Project	IEEE 802.16 Broadband Wireless Access Working Group < http://ieee802.org/16 >	
Title	Text updates for Same-PHY signaling sections of Draft Document	
Date Submitted	2007-09-14	
Source(s)	John Sydor Communications Research Centre 3701 Carling Avenue Ottawa, Ontario	Voice: 613-998-2388 Fax: [Fax Number] john.sydor@crc.ca
Re:	Changes to Draft Standard	
Abstract	Changes primarily related to comments from sessions 49 & 50 and use of the new CXCC concept.	
Purpose	Editorial changes; technical changes due to new CXCC	
Notice	This document has been prepared to assist IEEE 802.16. It is offered as a basis for discussion and is not binding on the contributing individual(s) or organization(s). The material in this document is subject to change in form and content after further study. The contributor(s) reserve(s) the right to add, amend or withdraw material contained herein.	
Release	The contributor grants a free, irrevocable license to the IEEE to incorporate material contained in this contribution, and any modifications thereof, in the creation of an IEEE Standards publication; to copyright in the IEEE's name any IEEE Standards publication even though it may include portions of this

Figure h26—CSI and CMI locations in WirelessMAN-CX

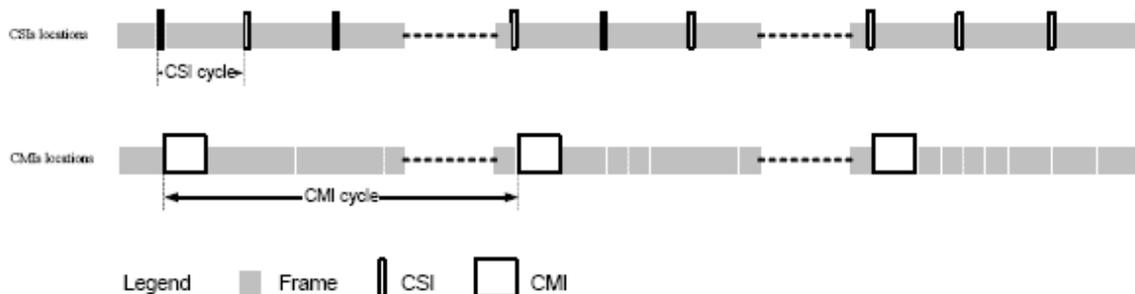
(10) Page 72, lines 50-65 Containing Figure h26 is recommended for deletion since it adds little to the understanding of CSI and CMI. The use of these has been given in greater detail in Ref 1.

DELETE

Figure h17 Example of claimed and unclaimed CMI (for a 5 Ms Frame Duration CXCC)

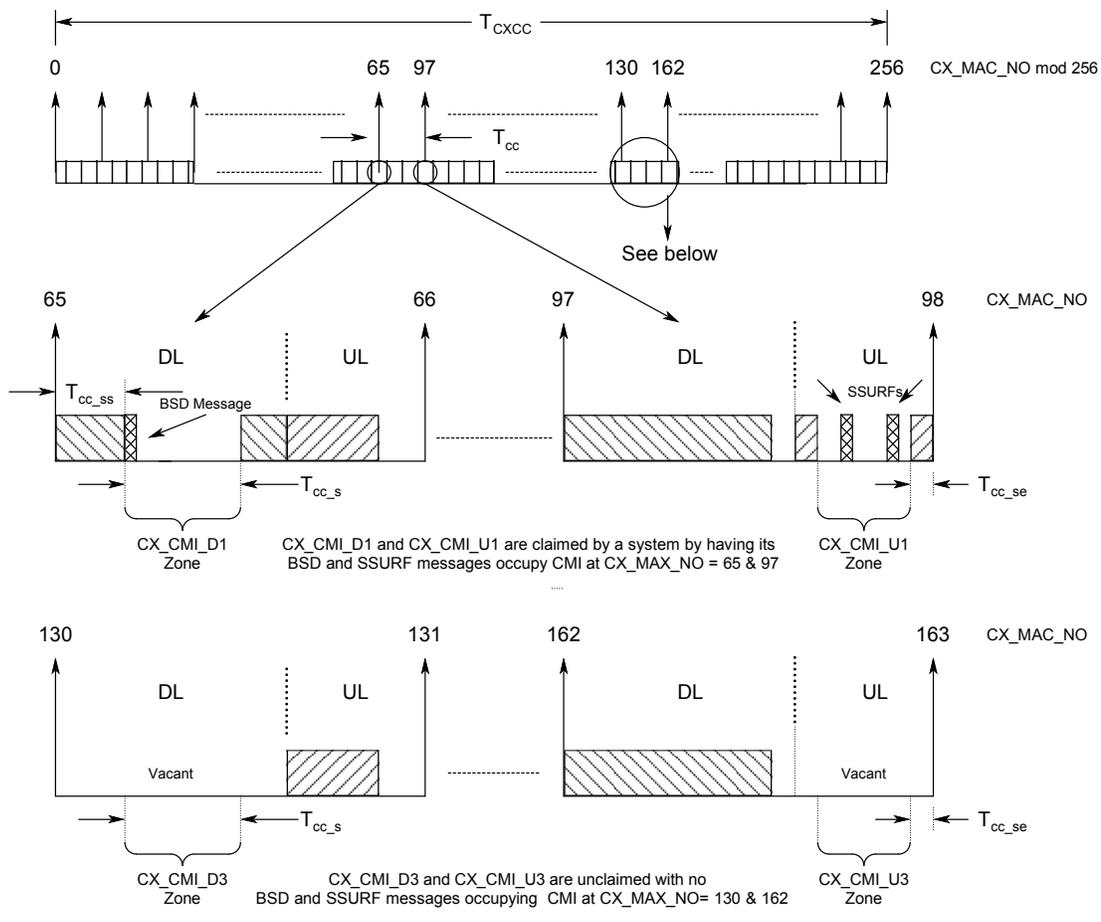
Insert this new modified figure h1, delete the one now in Ref 1.

Figure h48 Candidate Channel Determination Process

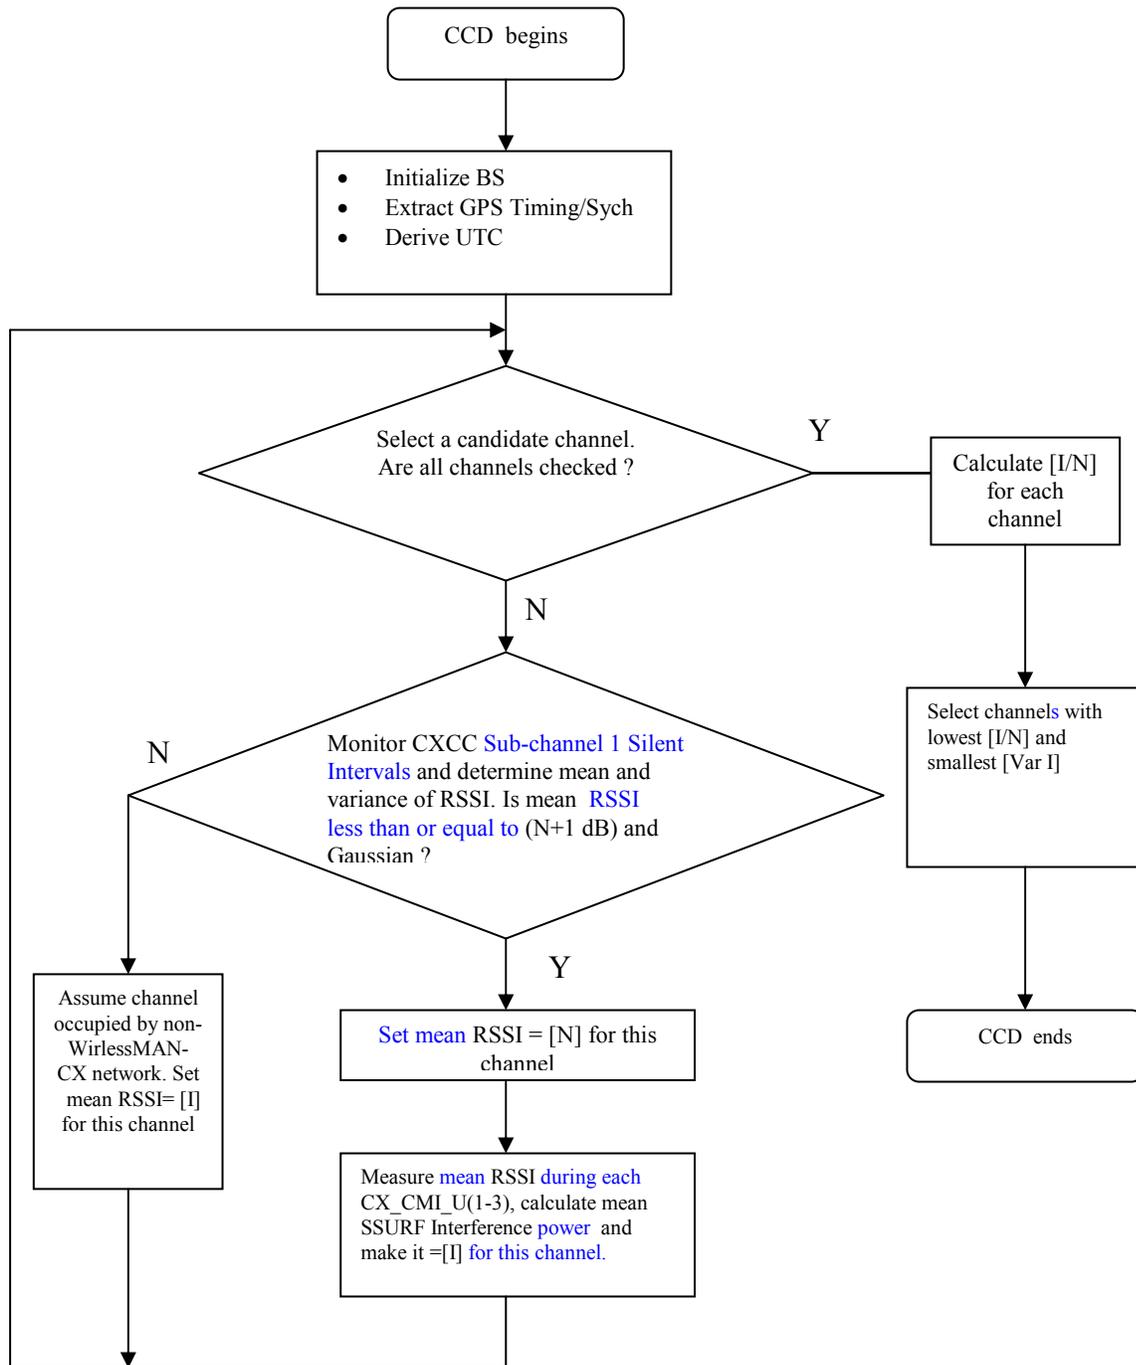
Delete the current Figure h48 on Page 104 of Ref 1 and replace it with the flowchart Provided below.

The channels are then ranked, with the channel having the lowest I/N and smallest [Var I] measurements likely selected for IBS entry into a Coexistence Community. This process is undertaken for each channel that is specified for the band of operation for the WirelessMAN-CX system and in essence identifies "white space" spectrum. Additionally, the passive PSD monitoring process described in section 15.5.1.19 15.5.1.20 can be considered as a parallel process to the CCD, and can be used as another method of ascertaining spectrum occupancy. *Figure h 48* shows the CCD process.
